ORDINANCE 95-30

TO AMEND THE BLOOMINGTON ZONING MAPS FROM
RS3.5/PRO6 to PUD,
AND APPROVE THE PRELIMINARY PLAN
Re: 2031 S. Weimer Road
(Cora Ann Sudbury, Petitioner)

Case #PUD-26-95
(RS/PUD/BL/PCD-26-95)

To: Rodney Young, Plan Commission Members
From: Kevin Komisarcik, Moira Wedekind
Subject: Sudbury Farm PUD
Date: June 21, 1995

POD-26-95
Site Plan

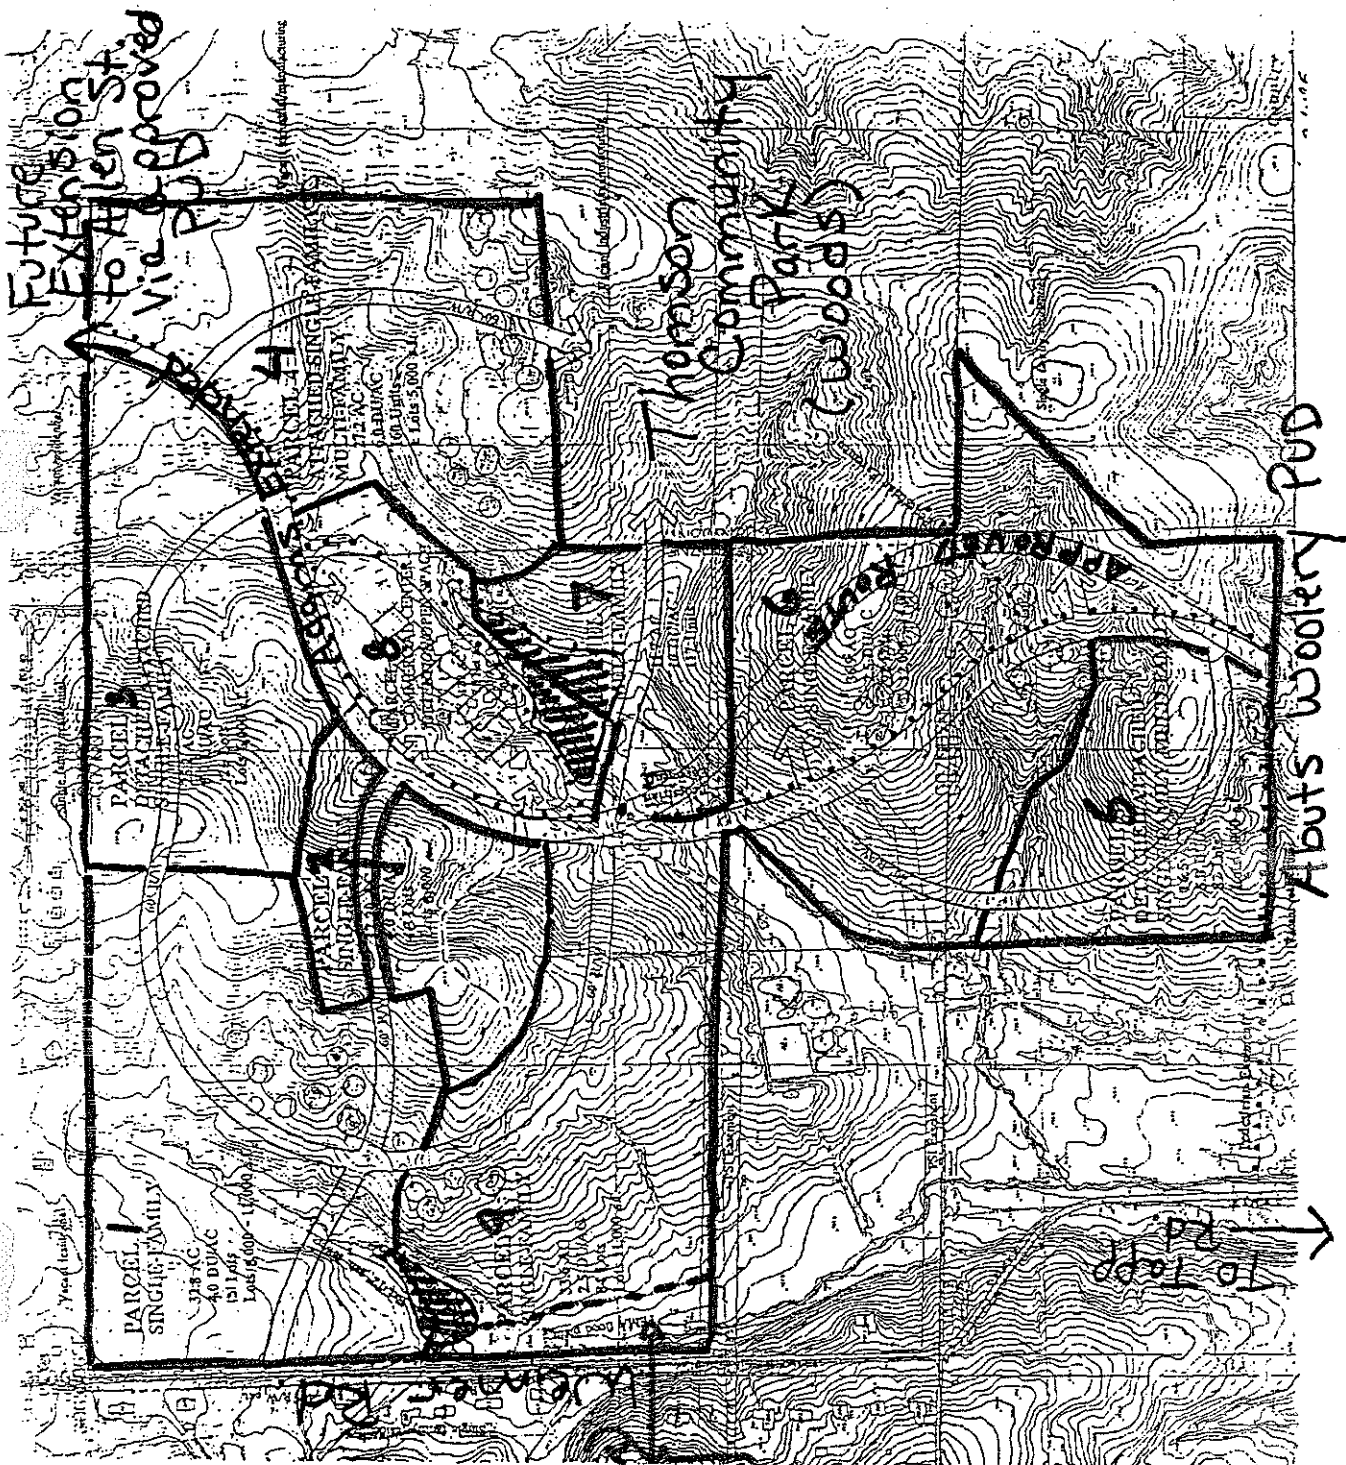
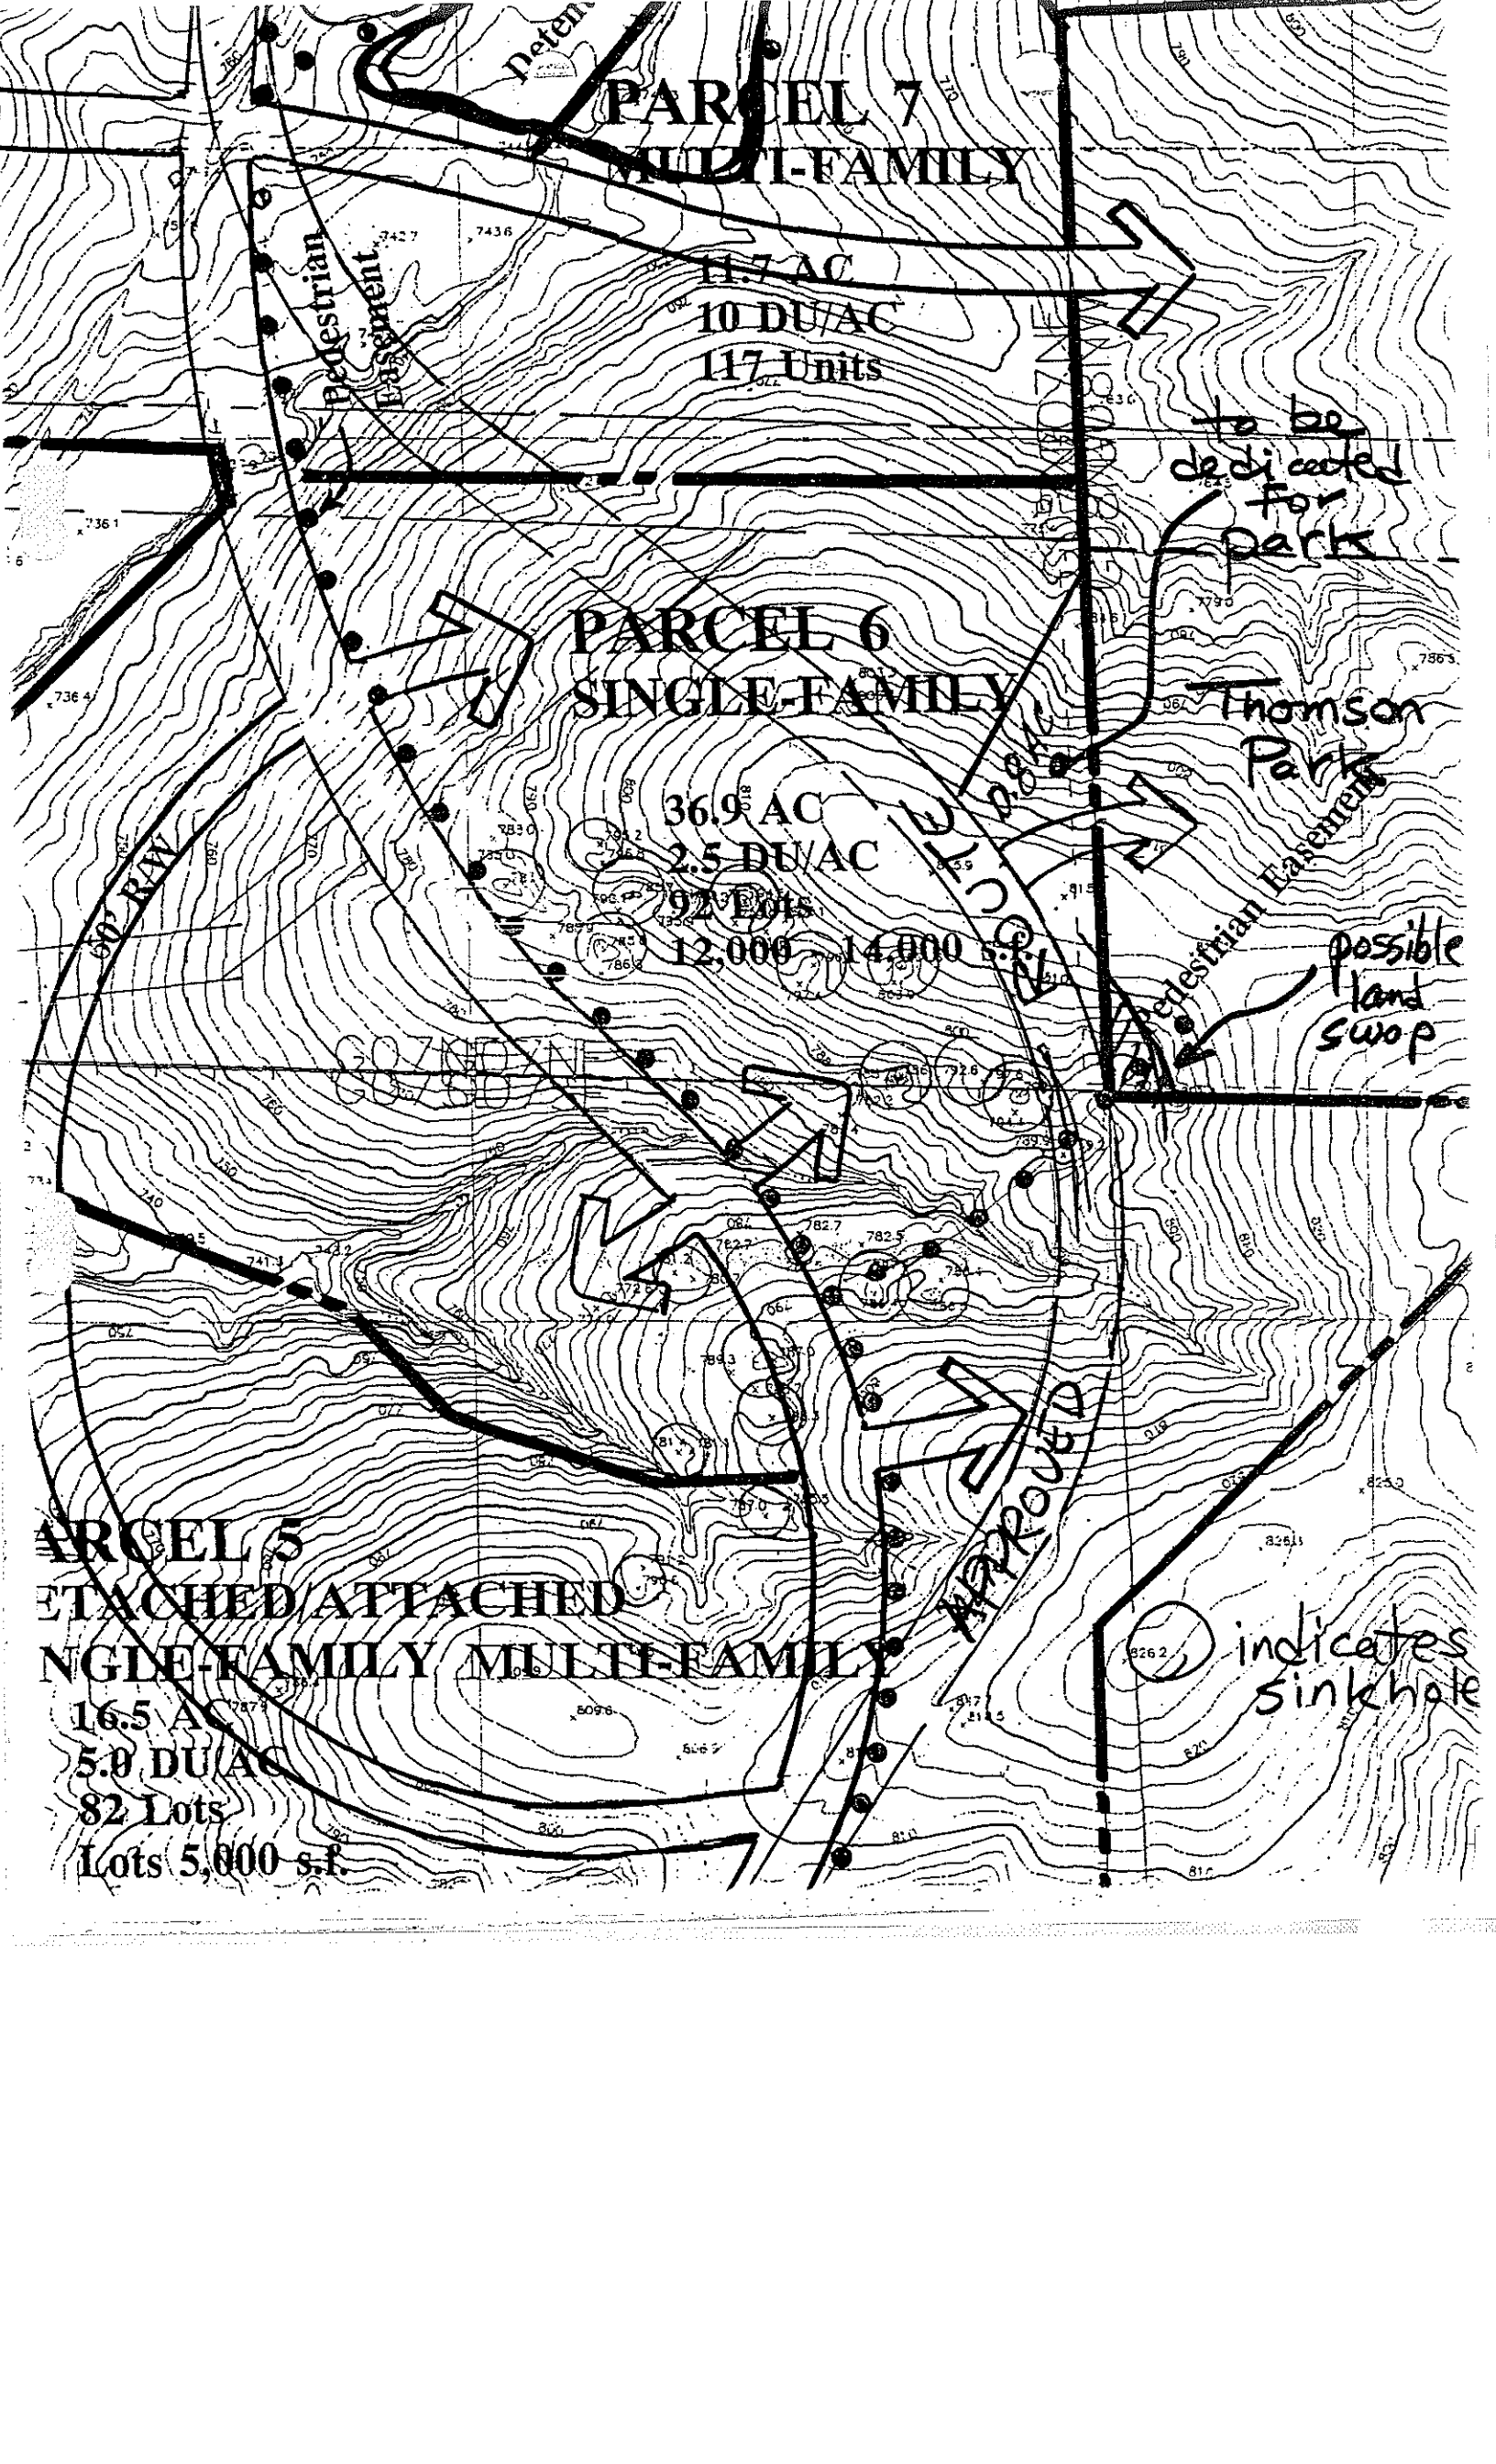
1. The original placement of the main arterial road is not well positioned given the karst features on this property. The road is placed such that it will impact a number of sinkholes on the property. As you know, the new city ordinance prohibits building within 25 feet of such features. We suggest two alternatives:

a. The road be moved towards the eastern boundary where it will be partially adjacent to Thompson Park, affording better access to its' western edge. This is the alternative route shown on the updated map.

b. The road be routed towards the western part of the development where it will be out of the forested area. This would follow the approximate location of the side street also shown on the map.

2. The proposed plan shows a band of higher density development partly in the forested area in the southern part of the site (parcel 5). We recommend that this portion of the development be moved to the non-forested area of the site (the western portions of parcels 5 & 6) and move more of the lower density development in parcel 6 into the woods. In other words the parcels would now align east - west rather than north - south. In this way more of the forest canopy will be saved.

Revised Adams alignment will relate better to sinkholes and grades. Generally, lower residential densities in tree areas will allow more preservation. Expect good detailing of specific preservation in final plans. Environmental Commission subcommittee comment has been considered by the Commission. The road has been revised but land uses remain as proposed.
